UNITED STATES PATENT AND TRADEMARK OFFICE

Office Action Summary

10/803,512

DETAILED ACTION

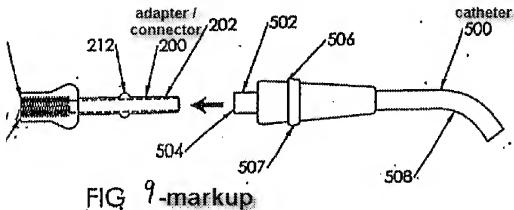
Regarding claims 30 and 44-45, Canaud discloses a catheter assembly in Fig. 9 comprising: a catheter 500 including at least one lumen; a connector/adaptor 200 (Figs. 2 and 9) or 270 (Fig. 3, note that the adaptor 270 is generally includes similar features of the adaptor 200 shown in Fig. 2, see para [0042]) including a distal end 202 attached to a proximal end 502 of the catheter and a passageway 206 (Fig. 2) or 278 (Fig. 3) in fluid communication with the at least one lumen 504, see Figs. 9-10; a proximal portion of the passageway including an engagement feature (i.e. element 208 having a thread connection

214 (Fig. 2), 286 (Fig. 3)) configured to connect an end of an instrument (i.e. tulener 300 or a port 400, see Fig. 1) to the connector 200 or 270; a distal portion of the passageway 278 including a valve 272 longitudinal fixed (firmly in position) with respect to the connector 270. Canaud further discloses that other types of valve (i.e. duck valve or slit valve) may be used in the adapter 270, see para [0043], therefore, one of examples of the type of duckbill valve 424 in Fig. 7 can be used in the adapted 270; wherein the valve having a closed proximal end with a slit (as well-known in the duckbill valve art) and open distal end, (see valve 424 of Fig. 7) and the proximal end of valve 272 distal of the engagement feature 286.

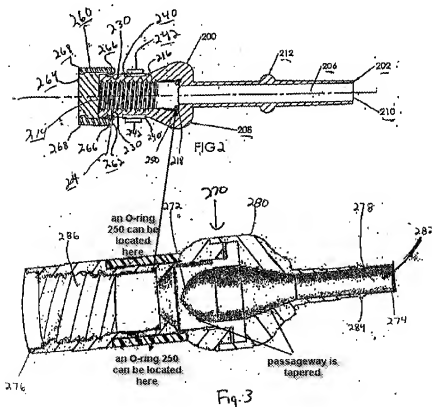
Regarding claim 31, note that the valve includes a wall defining a lumen from the proximal end to the distal end, the wall configured to or (adapted to/capable of) to guide a proximal end of a guide-wire from the valve distal end through the slit in the valve proximal end.

Regarding claim 33, note that Canaud discloses the engagement feature 208 of adapter 200 in Fig. 2 comprises an O-ring 250 to help facilitate sealing between the adapter and port 400 or the tunneler 300, (see para [0039]) while the engagement feature of adapter 270 does not include an O-ring, however, one skill in the art would recognize that the O-ring 250 can be located in the adapter 270 for the purpose of helping facilitate sealing between the adapter and port 400 or the tunneler 300. Note that, a wall defining the proximal portion of the passageway proximal of the O-ring is tapered, see Fig. 3 below.
